# Addendum No. 2

**PROJECT:** Vivie Nelson Care Center Renovation, Alexandria, MN

**From:** Wold Architects and Engineers

**Subject:** Addendum No. 2 for Bidding Documents for the
**Vivie**
**Nelson Care Center Renovation**
**Alexandria, Minnesota**

# E0.011b

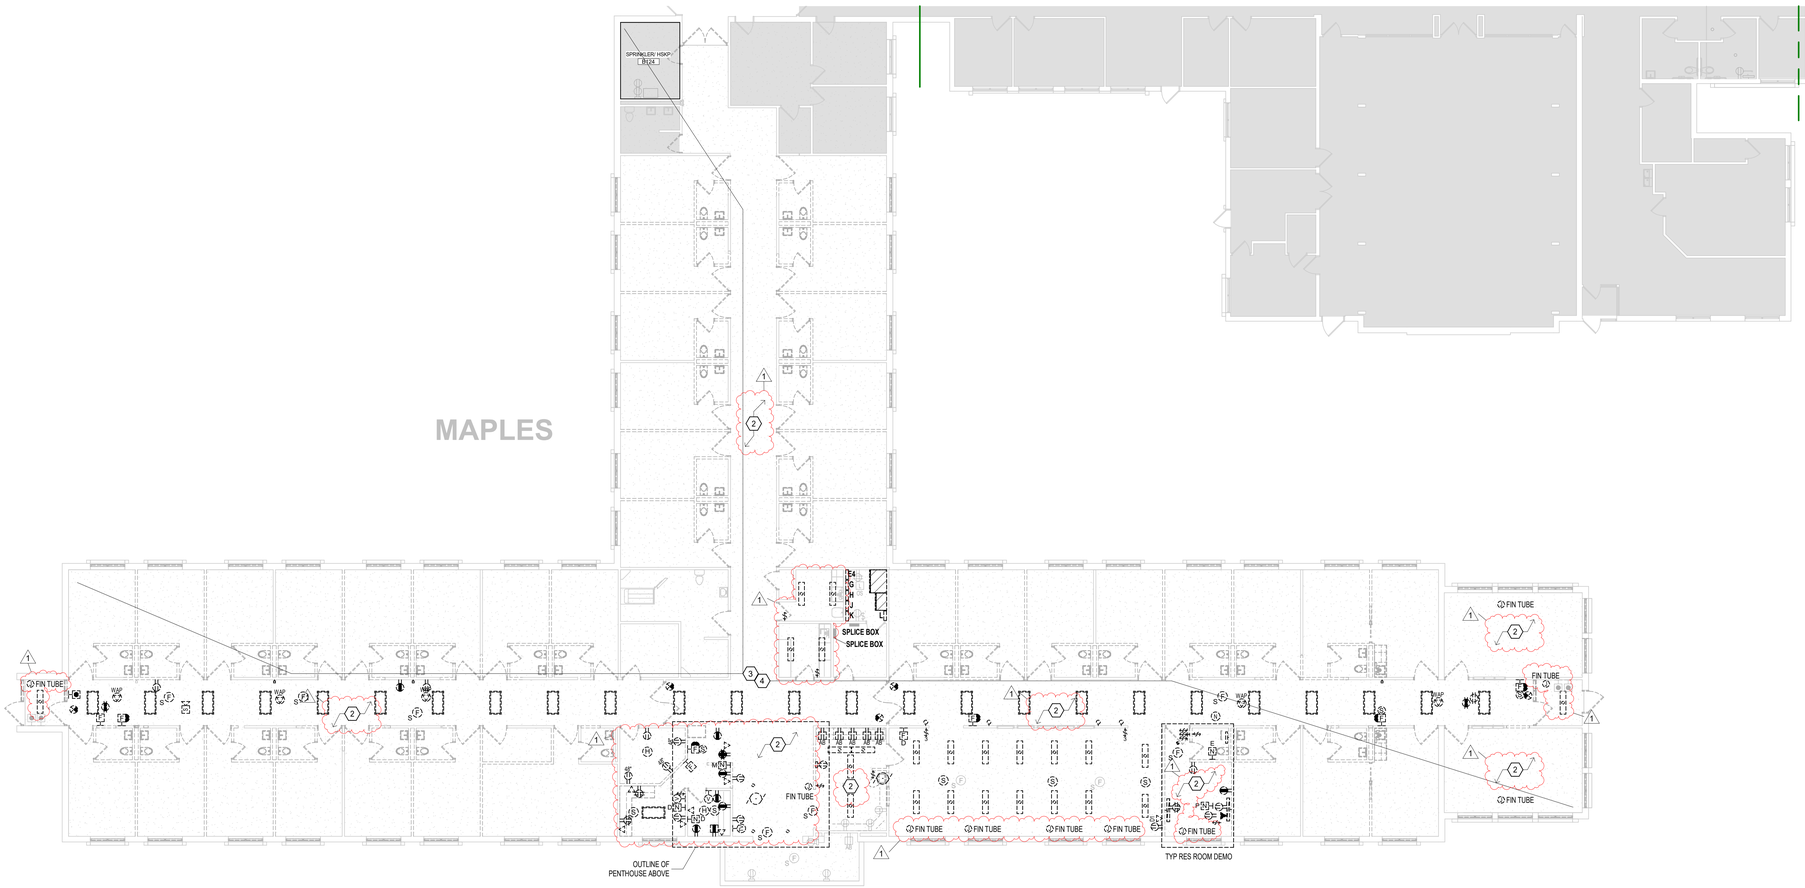
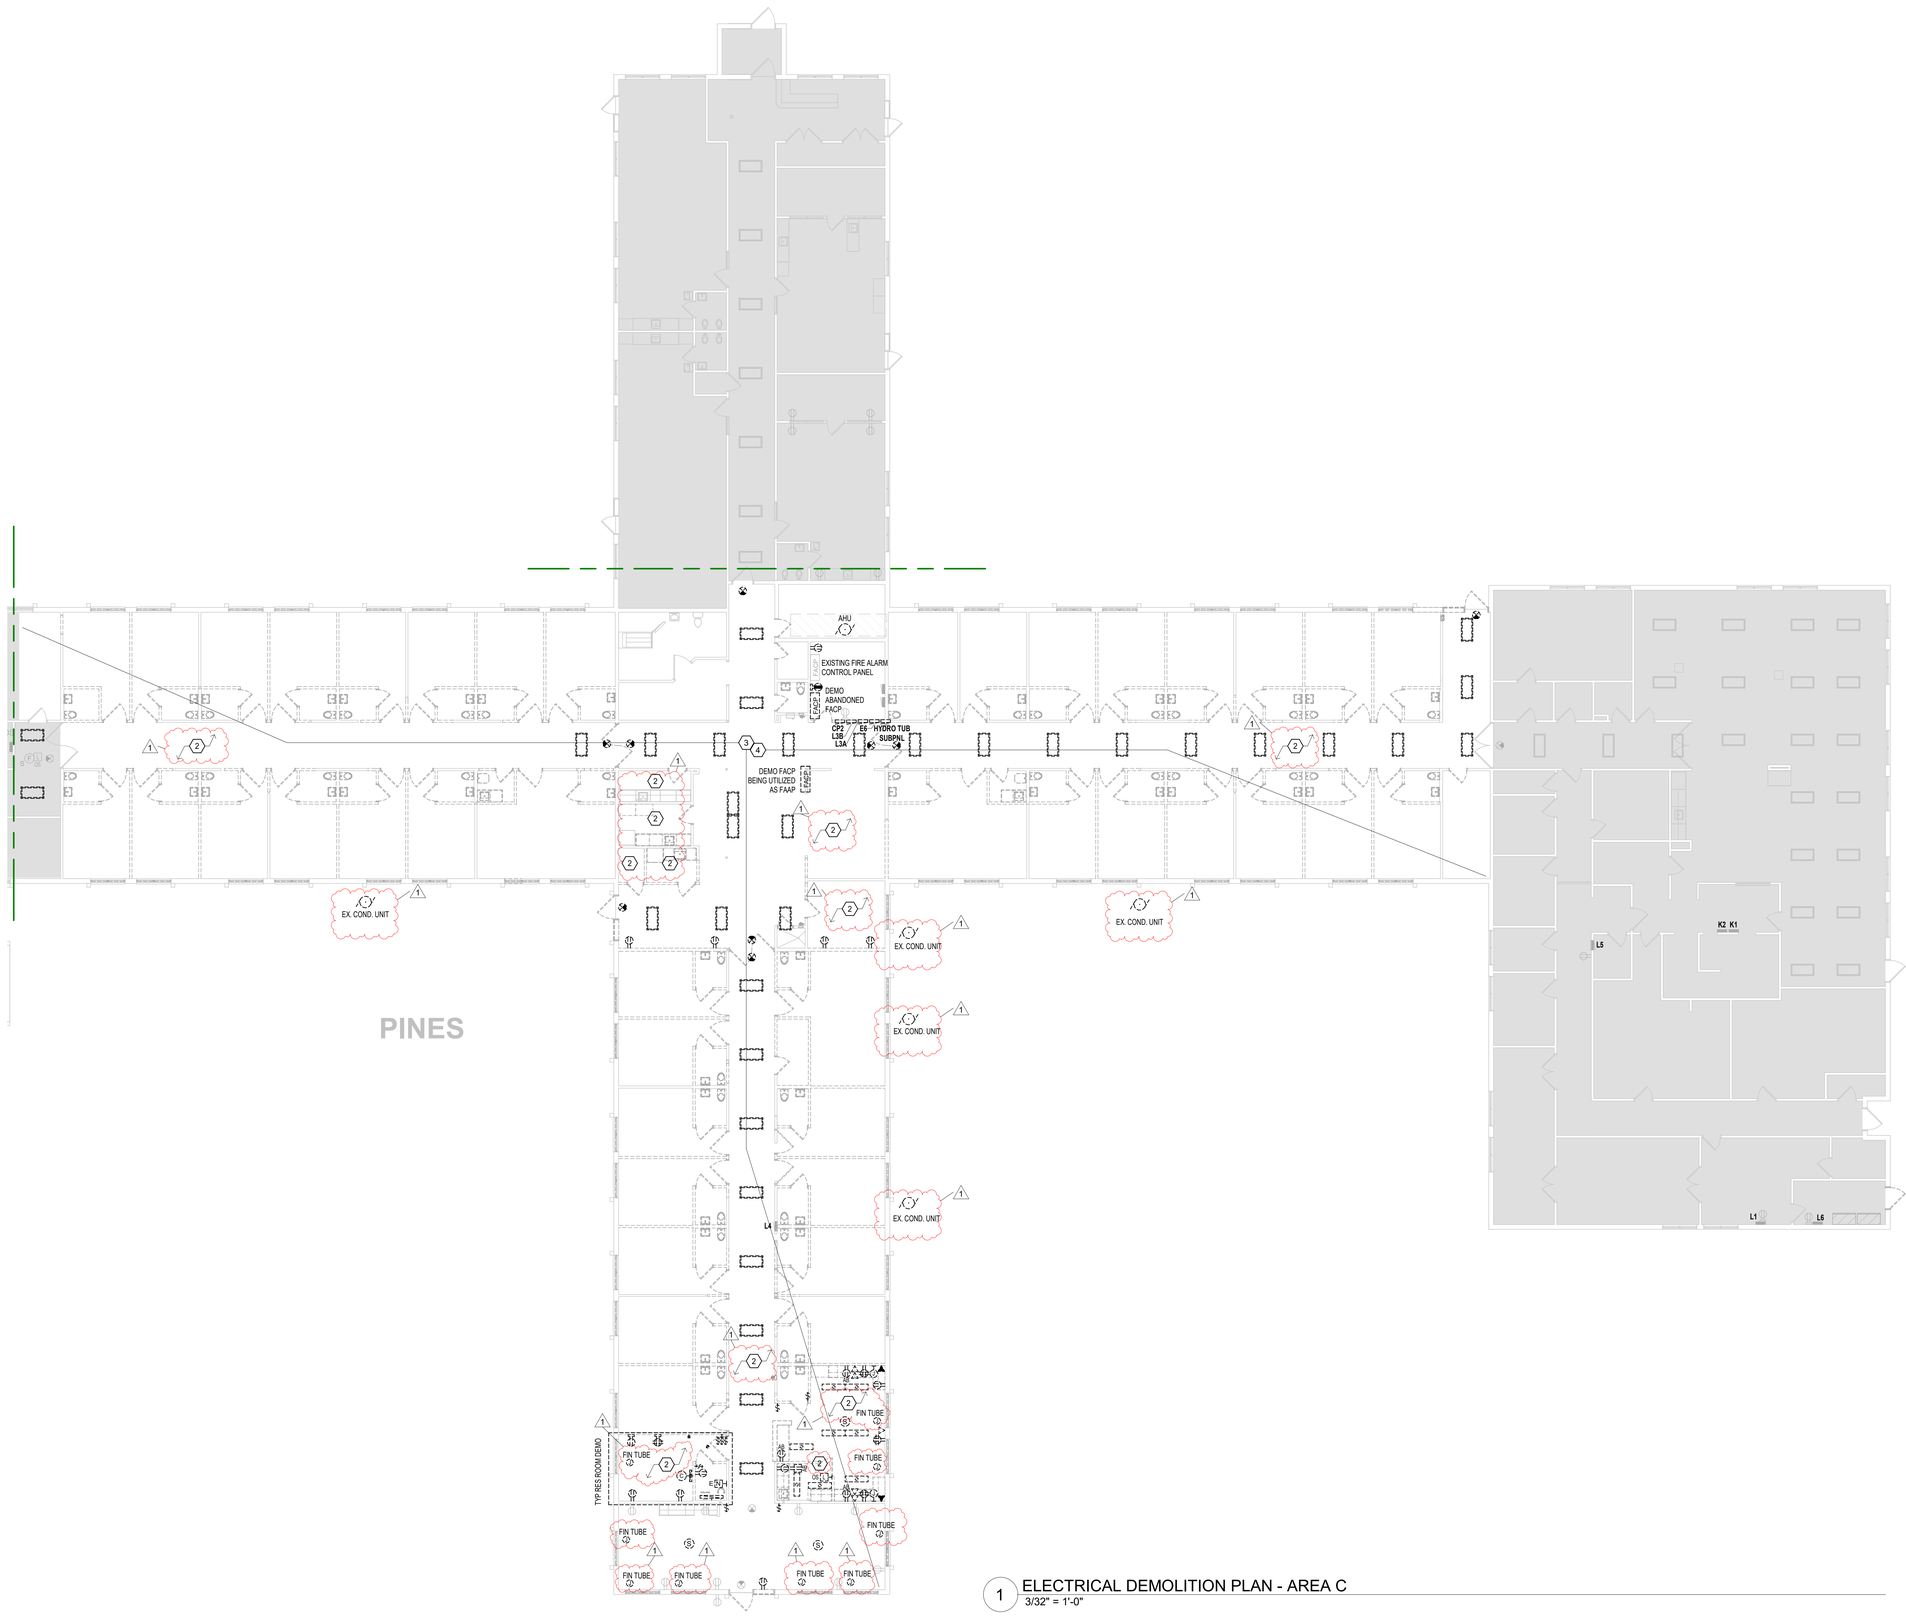
42. **DRAWING E0.011b - ELECTRICAL DEMOLITION PLAN - AREA 'B'**
    A. **Reissued this addendum**
        i. Clarification of electrical demolition.
        ii. Demolition of existing electrical fin tube and condensing units.

# E0.011c

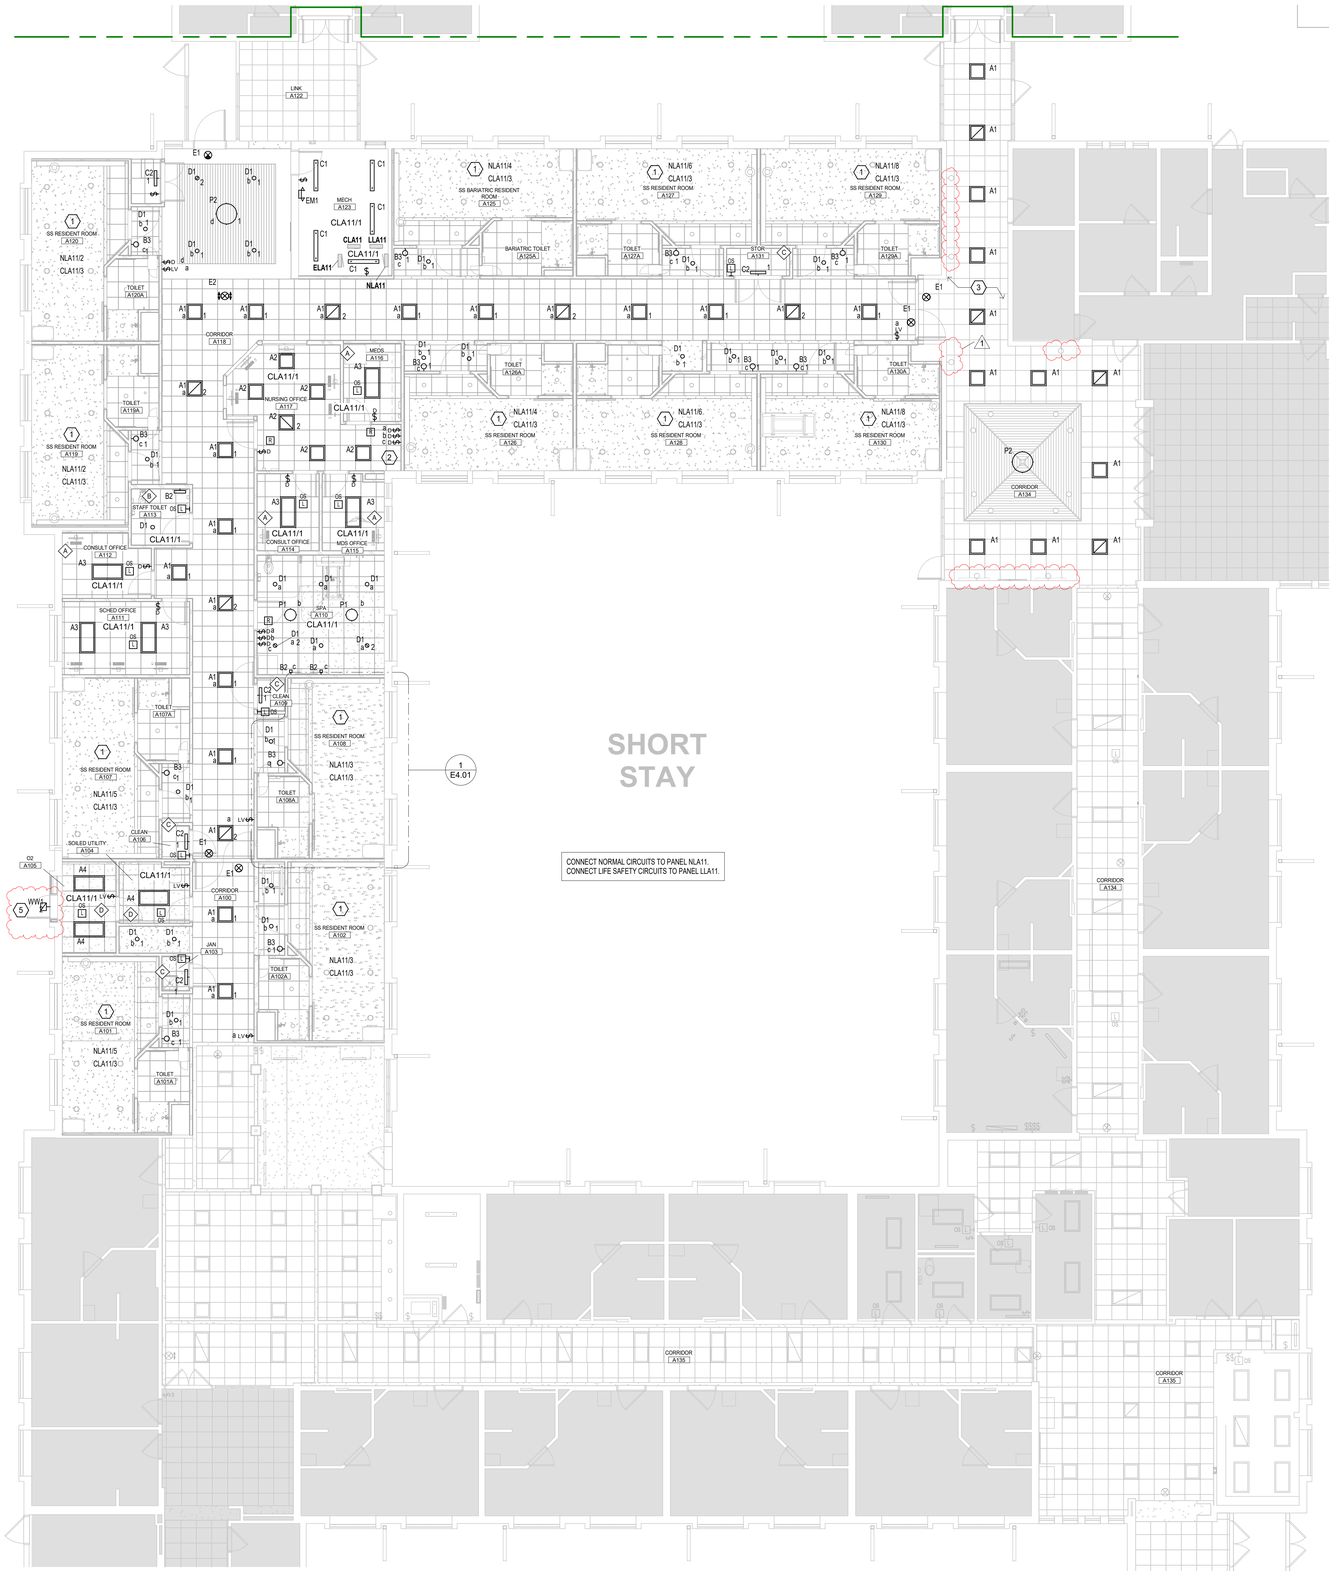
43. **DRAWING E0.011c - ELECTRICAL DEMOLITION PLAN - AREA 'C'**
    A. **Reissued this addendum**
        i. Clarification of electrical demolition.
        ii. Demolition of existing electrical fin tube and condensing units.

# E1.001b

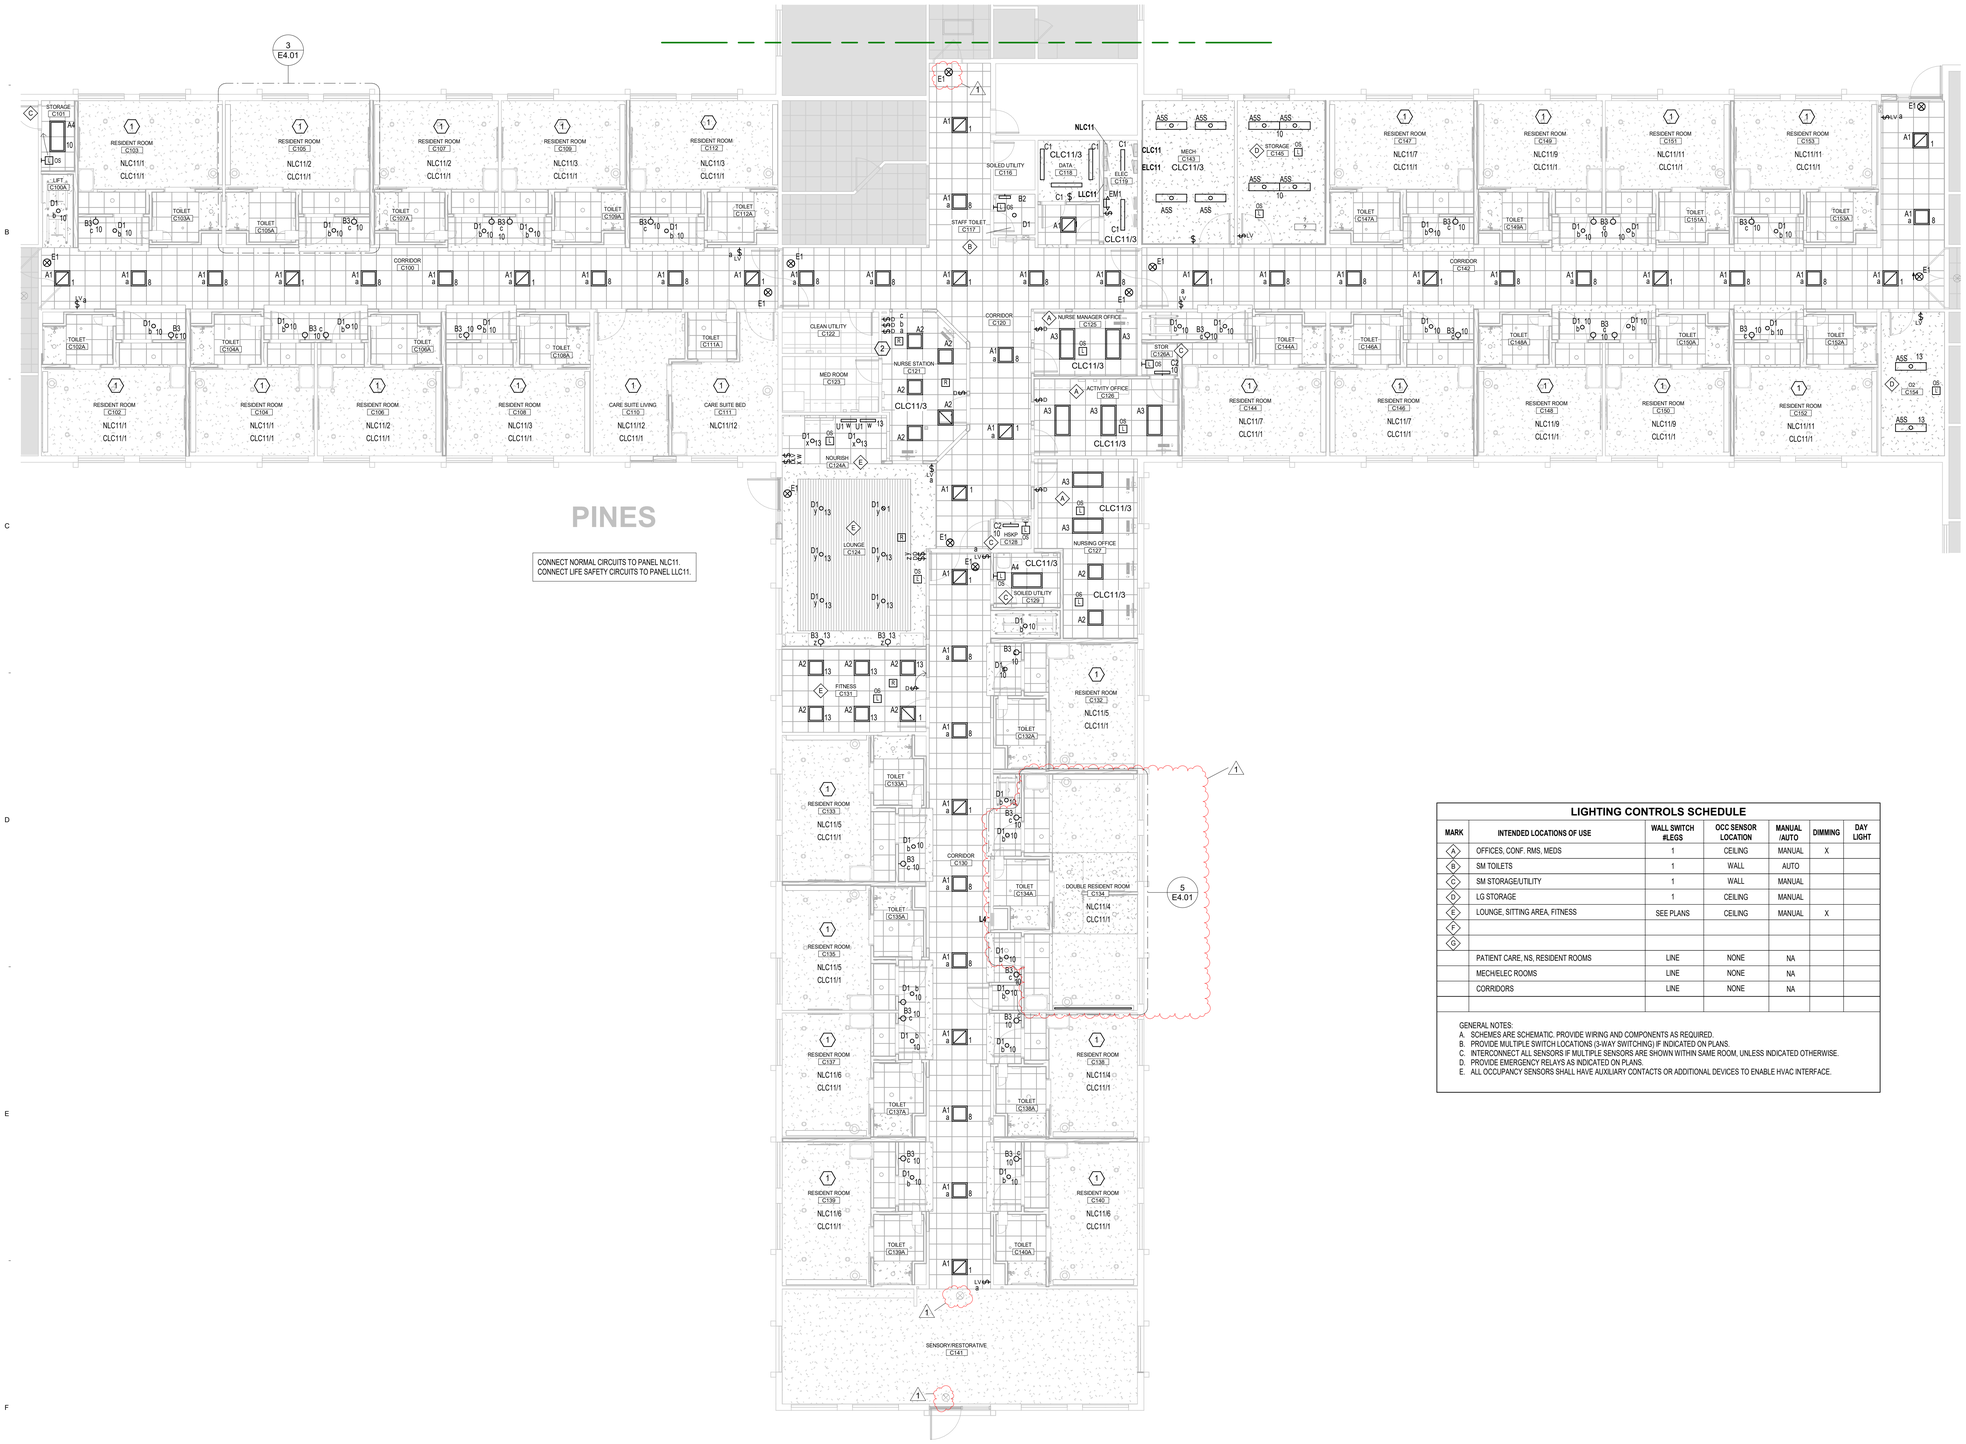
A. **Reissued this addendum**
        i. Additional lighting scope.
46. **DRAWING E1.001c - LIGHTING PLAN - AREA 'C'**
    A. **Reissued this addendum**
